**From: WDSC Ballot I for Special Provisions for Wind & Seismic (SDPWS)  
(04/2014)**

**Finding of Non-Persuasive on Ballot I-1 Lawless Negative**

Item	Section	Item Description			
I-1	All	<p>Approve SDPWS as shown in "Attachment A – SDPWS Running Version.pdf".</p> <p>Proposed revisions resulting from WSTC Ballots 1 through 6 are incorporated into the running draft. A summary of changes is provided in "Attachment B – Summary of SDPWS Changes.pdf".</p>

**Figure 1:** Histogram of Tested Shear Wall Capacity for 8d Box (2 3/8" x 0.113") Nails  
(Per SDPWS, 3/8" WSP with SPF framing 16" o.c. has a design value of 515 plf for 6d common (2" x 0.113") nails and 672 plf for 8d box (2 1/2" x 0.113") nails.)

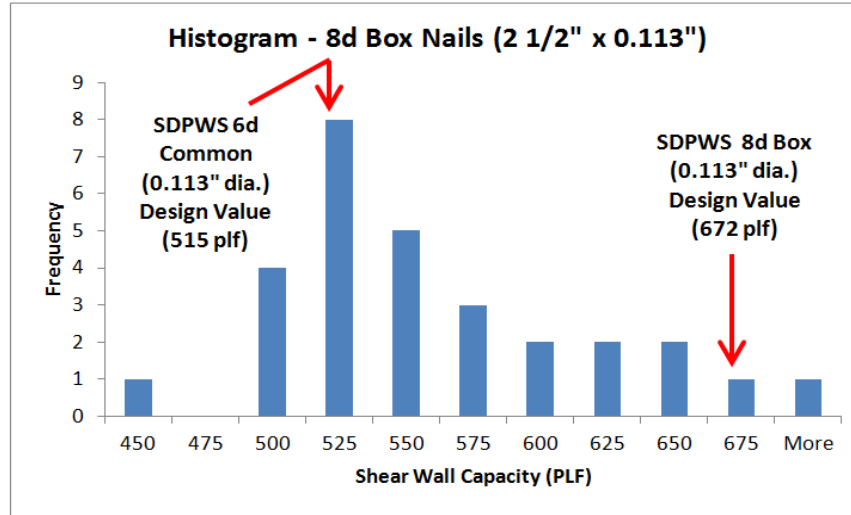
Furthermore, as currently written, Table 4.3A in *SDPWS* shows that a  $\frac{3}{8}$ " WSP shear wall with 8d galvanized box ( $2\frac{3}{8}$ " x 0.113") nails and a  $\frac{3}{8}$ " WSP shear wall with 8d common ( $2\frac{1}{2}$ " x 0.131") nails both have the same nominal unit shear capacity of 672 plf (730 plf multiplied by 0.92 for DF to SPF reduction). However, as shown in Figure 1, the nominal unit shear capacity for the 8d galvanized box ( $2\frac{3}{8}$ " x 0.113") nail has a median value between 500 and 525 plf, about 150 plf less than the design value given in *SDPWS*.

Since an 6d common (2" x 0.113") nail has the same diameter as the 8d galvanized box nail ( $2\frac{3}{8}$ " x 0.113"), the test results in Figure 1 were compared to the *SDPWS* design value for 6d common nails. Table 4.3A in *SDPWS* gives a nominal unit shear capacity of 515 plf (560 plf times 0.92 for DF to SPF reduction) for a  $\frac{3}{8}$ " WSP shear wall with 6d common (2" x 0.113") nails. This is comparable to the median shear capacity for the shear walls 8d galvanized box ( $2\frac{3}{8}$ " x 0.113") nails. It seems that the 8d galvanized box ( $2\frac{3}{8}$ " x 0.113") nail and the 6d common (2" x 0.113") nail should have the same design value as the only difference between the two fasteners is the  $\frac{3}{8}$ " greater fastener penetration of the 8d galvanized box nail. However, the provisions of *SDPWS* inaptly state otherwise. See the attached article ("Lawless2.pdf") titled "Installation & Fastening of Wood Structural Panel Wall Bracing" from the March 2014 SBC Magazine for further information on the differences between box and common nails.

Substitution of galvanized box nails for common nails in shear walls has been raised in the past. Both APA and CUREe studied this issue and concluded that the difference was insignificant. However, the group encouraged Lawless to provide the full test reports of SBCA's shear wall tests if he felt they provided more information that needs to be considered. If the test reports are provided, this issue will be considered next cycle.
